HISTORIC AND DESIGN REVIEW COMMISSION

March 17, 2021

HDRC CASE NO: 2021-118
ADDRESS: 1003 N HACKBERRY ST
LEGAL DESCRIPTION: NCB 520 BLK 24 S 60 FT OF 17 & 18 ARB A17
ZONING: IDZ, H
CITY COUNCIL DIST.: 2
DISTRICT: Dignowity Hill Historic District
APPLICANT: Lawrence Briseno/MUNOZ LARRY GENE
OWNER: Lawrence Briseno/MUNOZ LARRY GENE
TYPE OF WORK: change in roofing material, front yard fencing
APPLICATION RECEIVED: January 28, 2021
60-DAY REVIEW: Not applicable due to City Council Emergency Orders
CASE MANAGER: Huy Pham

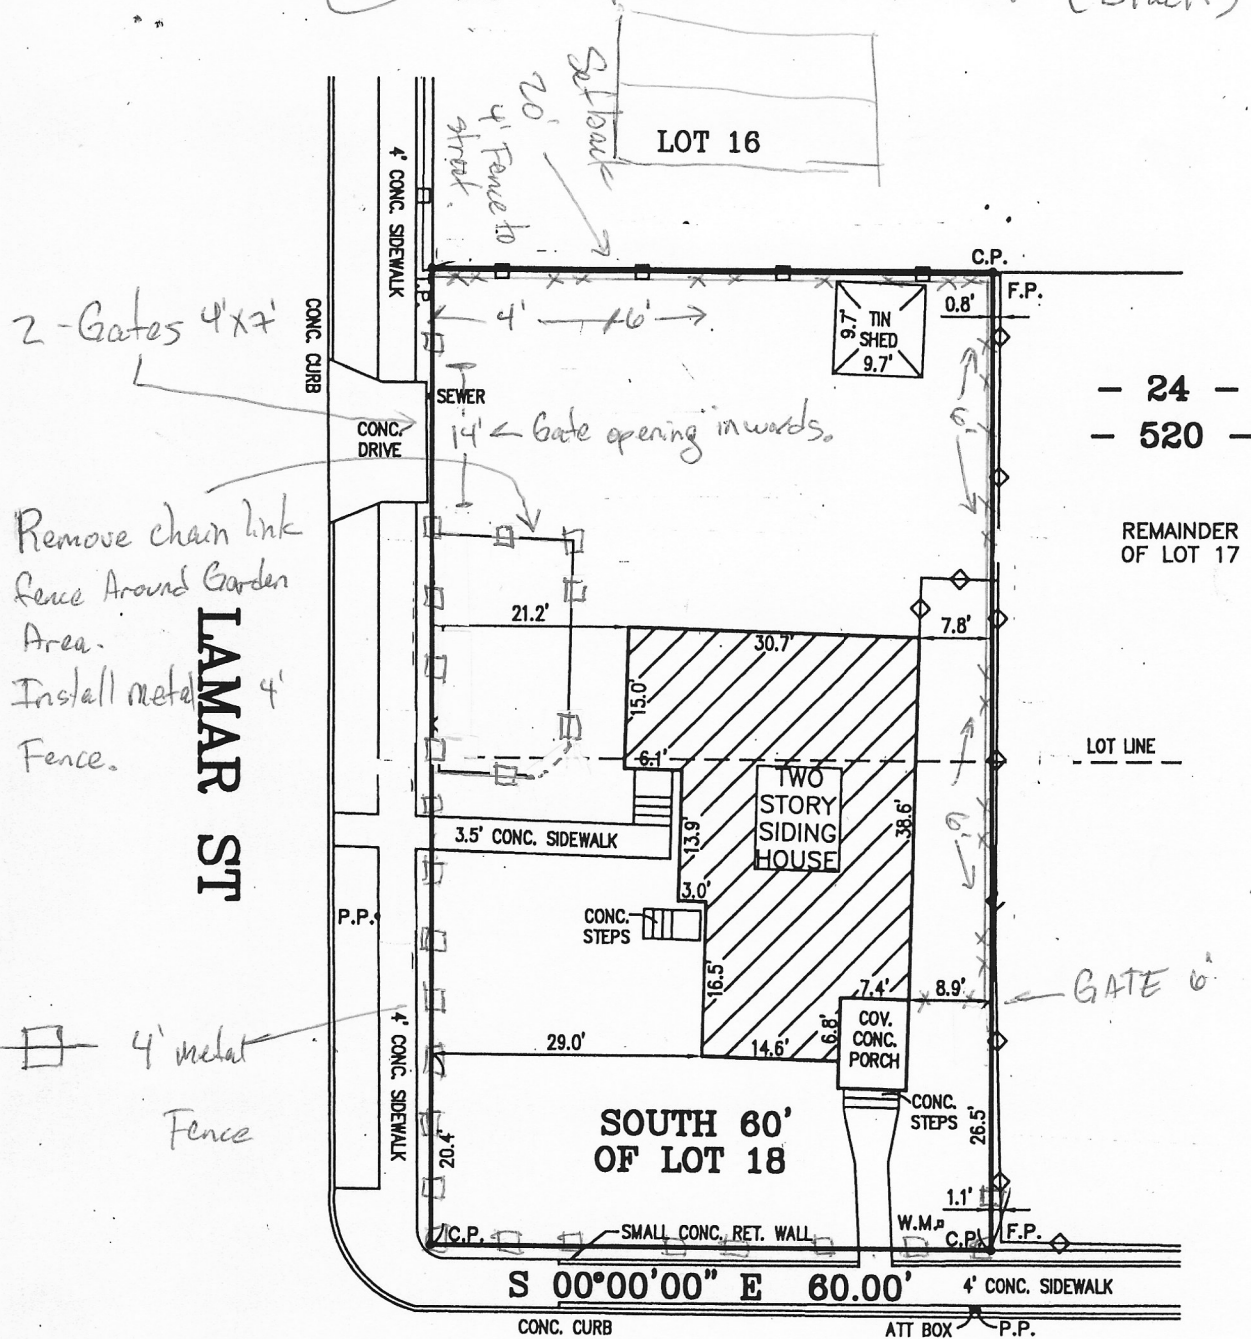
- d. FENCING – The applicant has proposed to install a 4-foot tall wrought iron fence on the property line on N Hackberry and Lamar, including a rear driveway gate on Lamar. Staff finds the proposed fencing is consistent with the Guidelines for Site Elements regarding fence location, height, material, and design and is appropriate for the corner property.

Staff recommends approval of item 2. front yard fencing as proposed based on finding d.
